HISTORIC AND DESIGN REVIEW COMMISSION

HDRC CASE NO: 2017-555

ADDRESS: 113 LINDELL PLACE **LEGAL DESCRIPTION:** NCB 6201 BLK 2 LOT 21

TYPE OF WORK: Rehabilitation, construction of an accessory structure, exterior modifications and

PROPOSED SITE / ROOF PLAN
SCALE: 1"=10'-0"

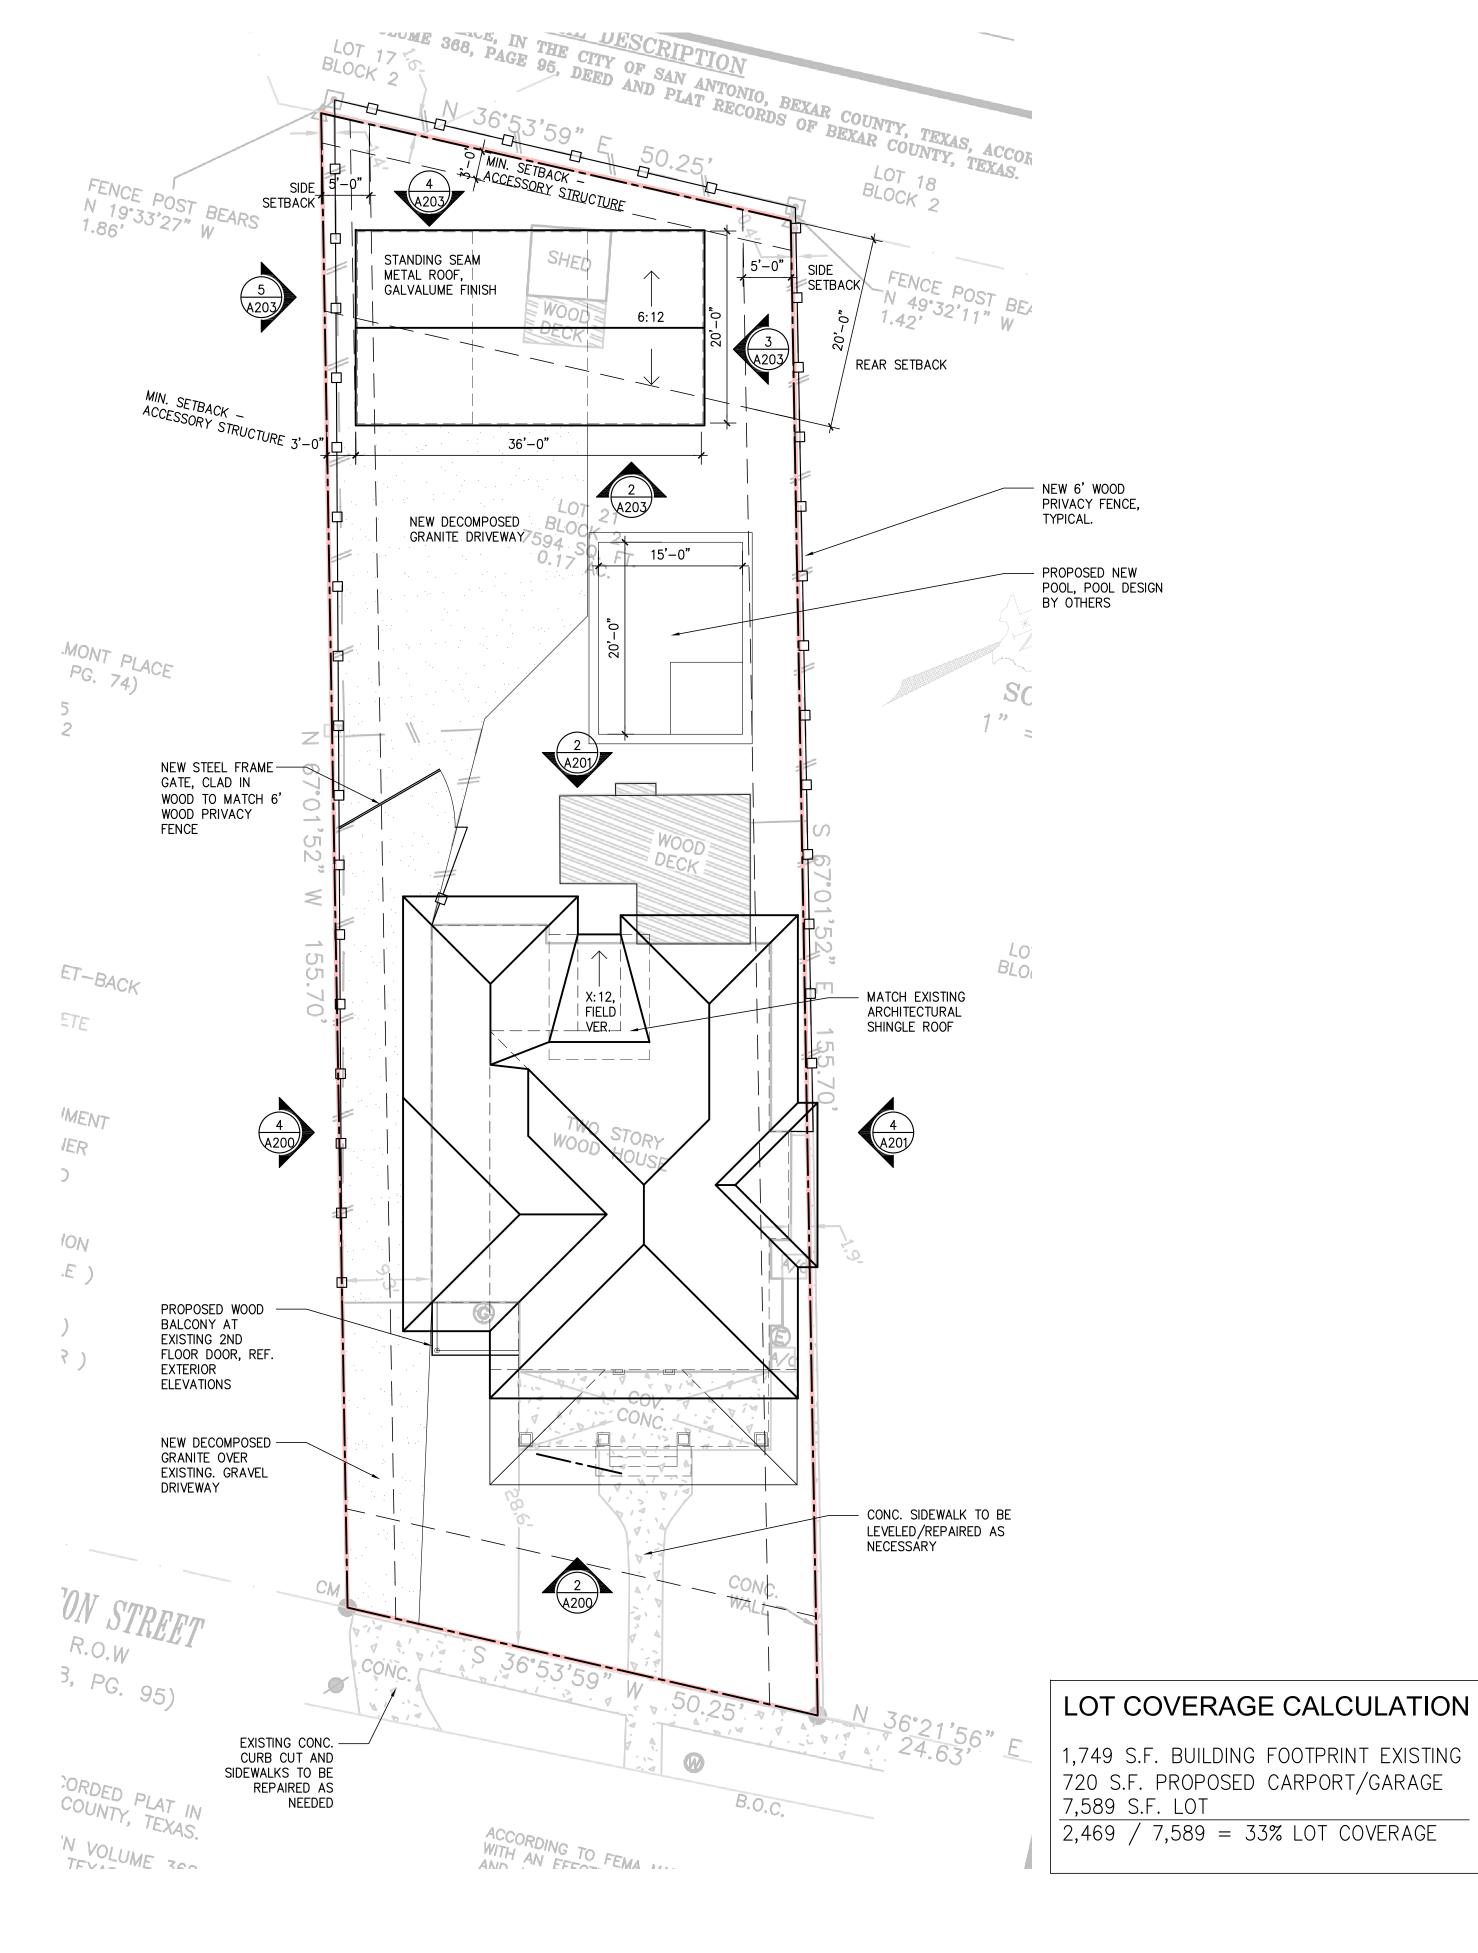
- d. SITE MODIFICATIONS The applicant has proposed site element repair and modifications which include the repair and leveling of the existing concrete driveway apron, sidewalks and walkways, to install decomposed granite over the existing, gravel driveway and to install a swimming pool in the rear yard. Staff finds the proposed repairs and modifications appropriate; however, the profile and width of the existing apron, sidewalk, walkways and driveway should not change with the exception of the expansion of decomposed granite in the rear yard as proposed. The driveway should not exceed ten (10) feet in width in the front yard. Staff finds the installation of the rear yard swimming pool appropriate.

- i. That the applicant provide staff with a balcony railing detail for approval as noted in finding b.
- ii. That the apron, sidewalks and walkways remain the same width and that the driveway not exceed ten (10) feet in width in the front yard as noted in finding d.

EXISTING & PROPOSED EXTERIOR ELEVATIONS

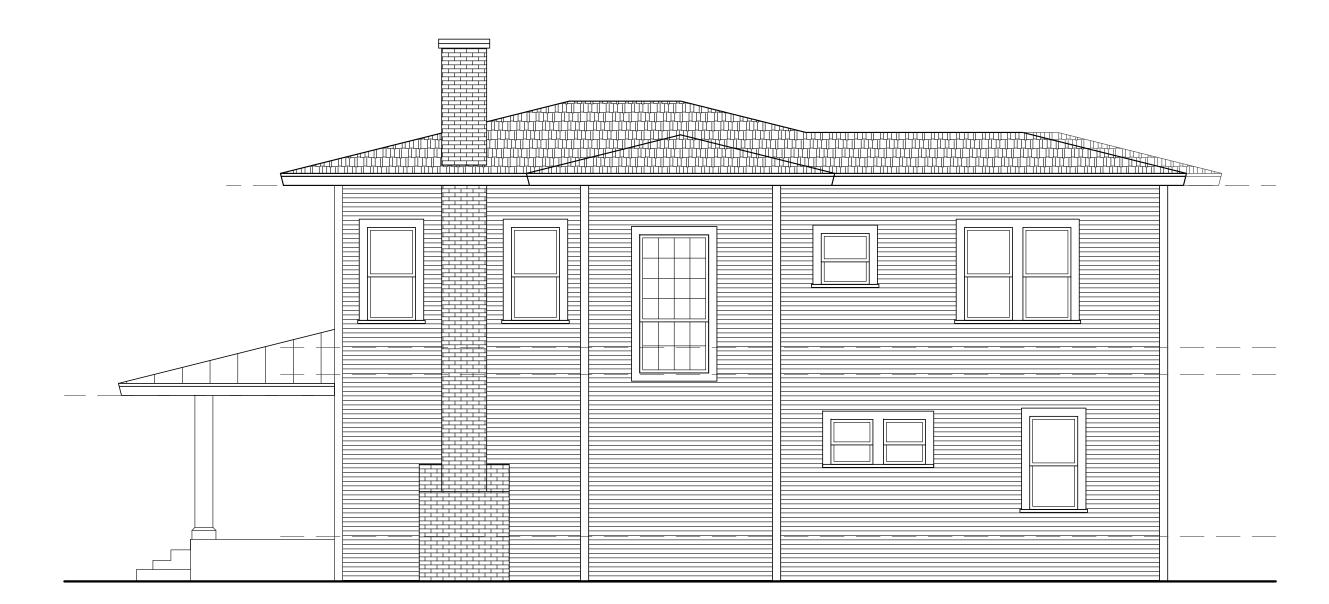
- e. EXTERIOR MODIFICATIONS The applicant has proposed exterior modifications to the rear of the structure that include partially enclosing a rear space between two previous additions, replacing a pair of French doors with sliding patio doors, replacing two windows with sliding patio doors, replacing existing wood siding with Hardi siding at the location where ganged windows will be removed for sliding doors and removal of the existing, non-original awnings.

- f. EXTERIOR MODIFICATIONS Each of the modifications noted in finding e are being made to previous additions; however, the siding and windows featured on these additions are architecturally appropriate for the structure. Staff finds the enclosure of the space between the two rear additions, replacement of the French doors with sliding doors, replacement of the two rear windows with sliding doors and the removal of the non-original awning appropriate. While not original to the structure, staff finds the proposed enclosure that is proposed to be Hardi siding feature a siding detail that is appropriate for the existing architecture, either horizontal siding with a four inch exposure or Hardi shingle siding. All removed wood windows are to be salvaged and stored on site when not reused on the existing structure.

- iii. That the proposed Hardi siding on the primary historic structure feature a horizontal profile or be Hardi shingles and feature an exposure of four (4) inches as noted in finding f.

BALCONY RAILING DETAIL

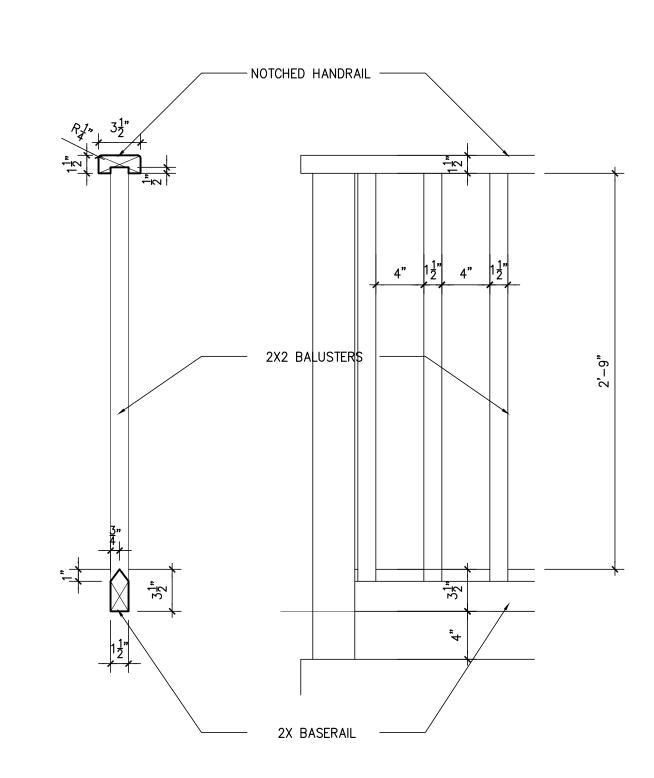
- b. BALCONY CONSTRUCTION The applicant has proposed to construct a balcony on the front façade of the historic structure to connect a side addition to the side façade of the primary historic structure where a second floor exterior door currently exists. The door opening appears to be a modified window opening and photos from 2011 note a non-original balcony at this location. The proposed balcony feature architecturally simplistic forms and profiling which staff finds will not distract from the Craftsman style of the historic structure. Staff finds the proposed balcony installation appropriate. The applicant is to provide staff with a railing detail for approval.

CARPORT-GARAGE
PLAN & EXTERIOR
ELEVATIONS

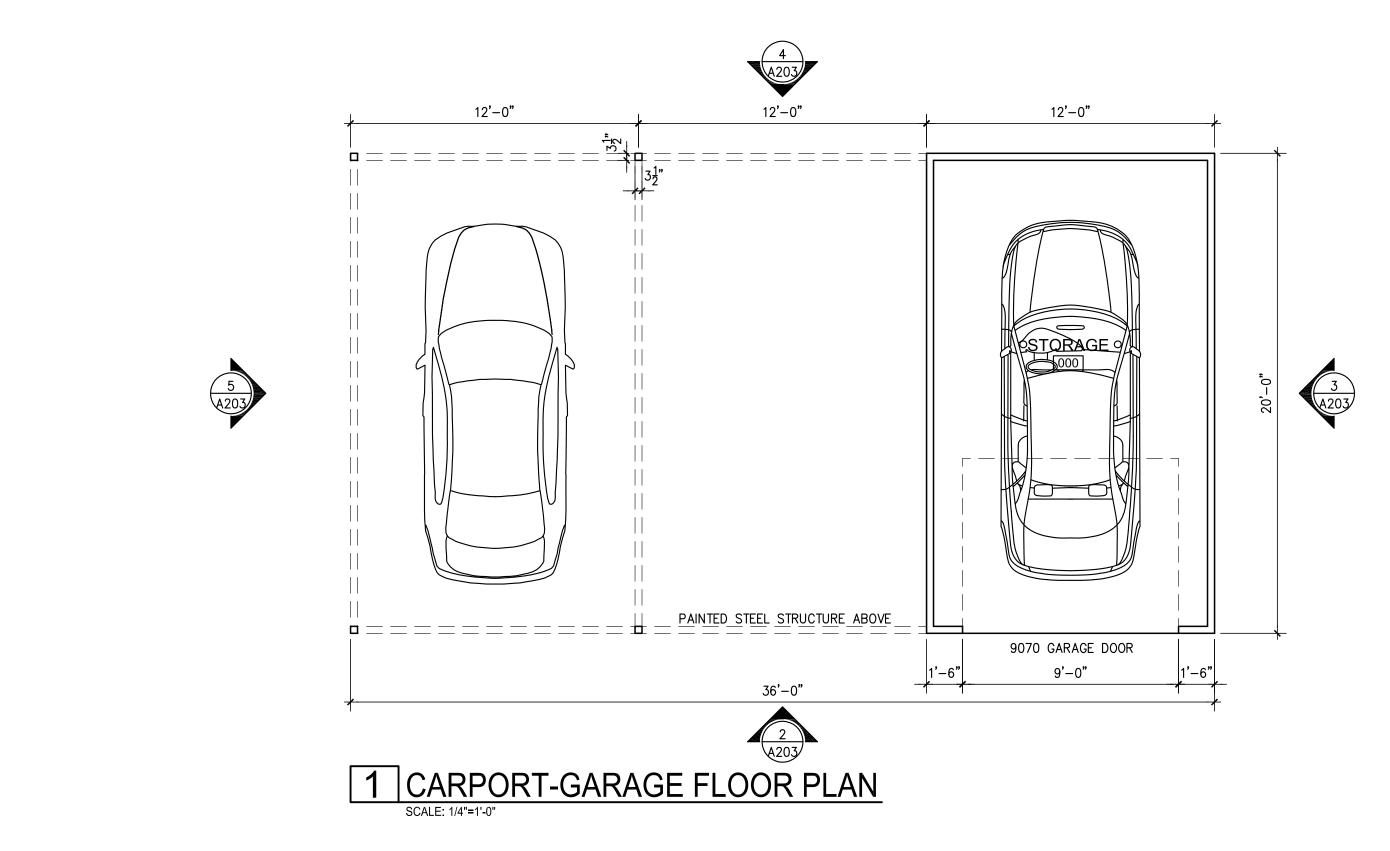
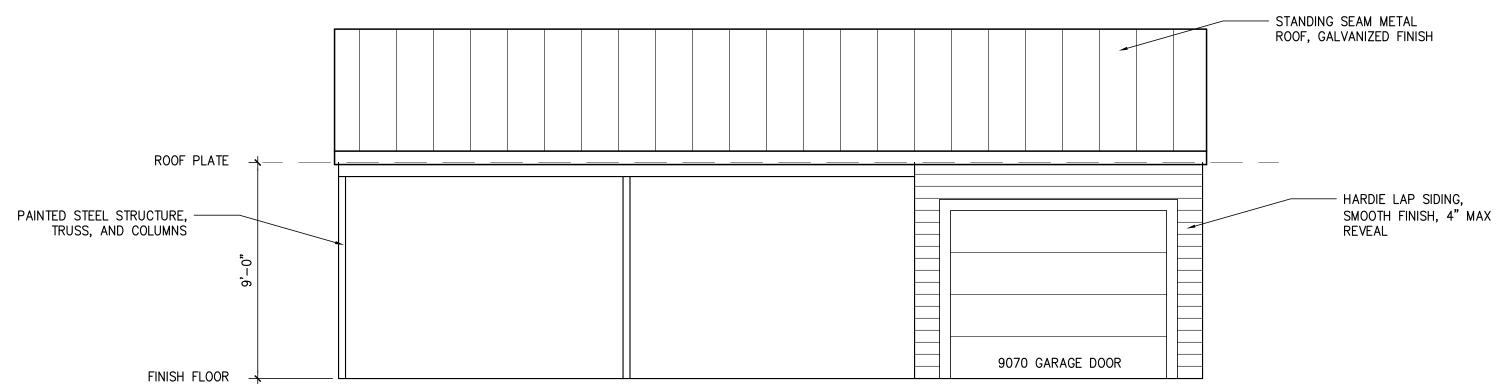
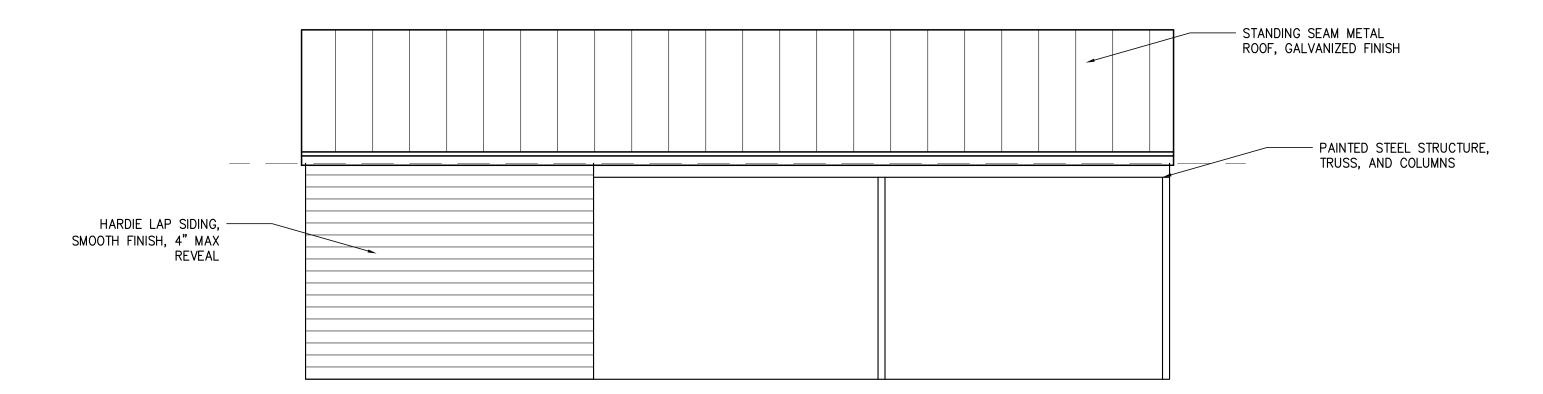
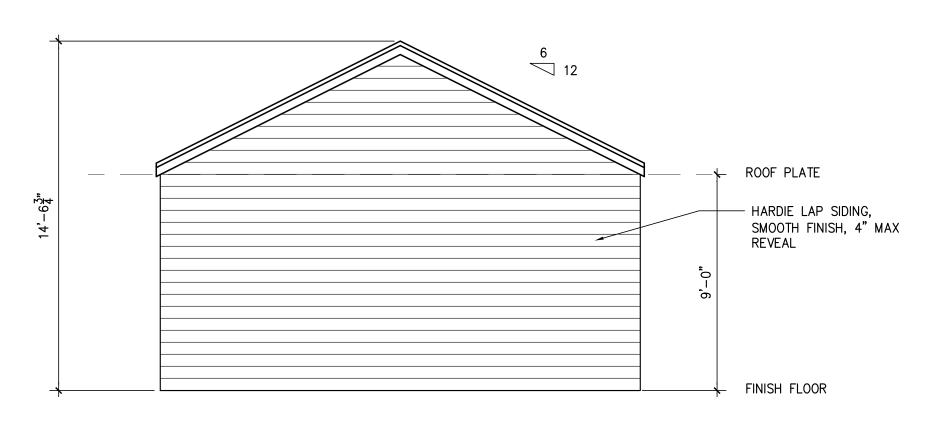
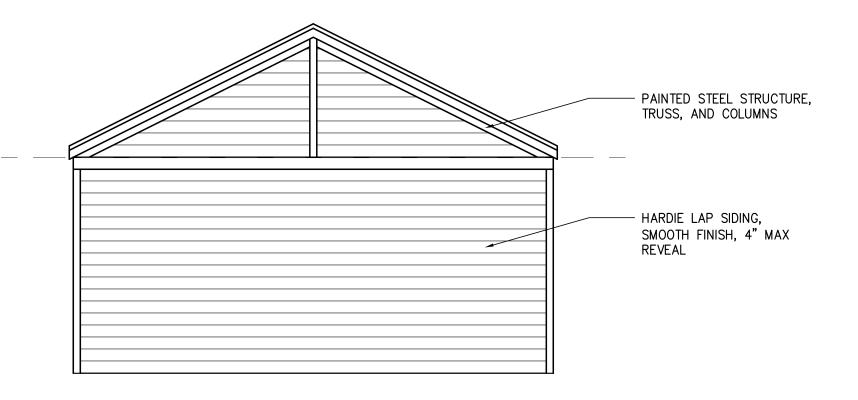
- g. ACCESSORY STRUCTURE The Guidelines for New Construction 5.A. notes that new garages and outbuilding should be visually subordinate to the primary historic structure in terms of their height, massing and form and should be no larger in plan than forty percent of the primary historic structure's footprint. The existing structure on the lot features a footprint of approximately 1,750 square feet. The proposed accessory structure features a footprint of 720 square feet. This is consistent with the Guidelines.

- h. ARCHITECTURAL DETAILS The Guidelines for New Construction 5.A.iii. and iv. note that new accessory structures should relate to the period of construction of the primary historic structure on the lot through the use of complementary materials and simplified architectural details. The applicant has proposed Hardi board and batten siding, a standing seam metal roof, and a painted steel structure. Staff finds the use of Hardi siding appropriate; however, staff finds that lap siding with a four (4) inch exposure would be more appropriate to relate to the horizontal wood siding of the primary historic structure. The proposed standing seam metal roof should feature panels that are 18 to 21 inches in width, seams that are 1 to 2 inches in height, a crimped ridge seam and a standards galvalume finish.

- i. GARAGE DOOR The applicant has proposed a single width garage door. Staff finds the installation of the garage door appropriate as well as its profile. Staff finds that the door should be painted to match the color of the proposed accessory structure.

- iv. That all removed wood windows are salvaged on site if not reused in this rehabilitation as noted in finding f.
- v. That the proposed rear accessory structure feature lap siding with a four (4) inch exposure to match that of the primary historic structure, that the standing seam metal roof feature panels that are 18 to 21 inches in width, seams that are 1 to 2 inches in height, a crimped ridge seam and a standards galvalume finish as noted in finding h.
